Access Compliance Report

Public Rights-of-Way

(Curb Ramps)

Intersection ID: 17310	Main Street: QUEENS_RD_WEST	Cross Street: SELWYN_AV	Location: NW
ADA ID: B863FA94E0D1	Ramp Type: Directional1	Initial Pass/Fail: Fail	Overall Compliance: No
Severity Score: 13.75			
Codes/Mitigation Info/Possible Solution		Field Measurements/Component Compliance

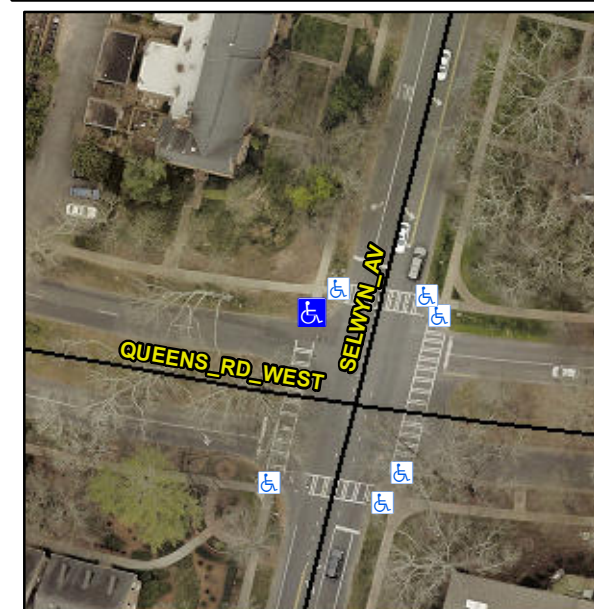
R304.2.2, R304.5.3

Compliance	Description	Data	Compliance	Description	Data
N/A	Ramp Length (in)	60.0	N/A	Grade Break?	N/A
Yes	Ramp Width (in)	48.0	N/A	Grade Break Slope (%)	0.0
No	Ramp Slope (%)	8.9	N/A	Grade Break XSlope (%)	0.0
No	Ramp XSlope (%)	4.2			
N/A	Flare Type LT	N/A	N/A	Flare Type RT	N/A
N/A	Flare Slope LT (%)	N/A	N/A	Flare Slope RT (%)	0.0
N/A	Flare Traversable LT?	N/A	N/A	Flare Traversable RT?	N/A
N/A	Landing Length (in)	0.0	N/A	DWS Provided?	N/A
N/A	Landing Width (in)	0.0	N/A	DWS Contrast?	N/A
N/A	Landing Slope (%)	0.0	N/A	DWS Length (in)	N/A
N/A	Landing X Slope (%)	0.0	N/A	DWS Full Width?	N/A
N/A	Landing Curb? (Y/N)	N/A	N/A	DWS Offset LT (in)	N/A
N/A	Shared Landing?	N/A	N/A	DWS Offset RT (in)	N/A
N/A	Gutter Ponding?	Yes	N/A	Gutter Slope (%)	N/A
N/A	Gutter Lip Ht (in)	0.0	N/A	Gutter X Slope (%)	N/A
N/A	Painted X Walk1?	No		Road Slope (%)	5.2
	X Walk 1 Direction	To S		Road X Slope (%)	1.7
	X Walk 1 Width (in)	N/A		Clear Space?	N/A

Remove & Replace Entire Ramp.
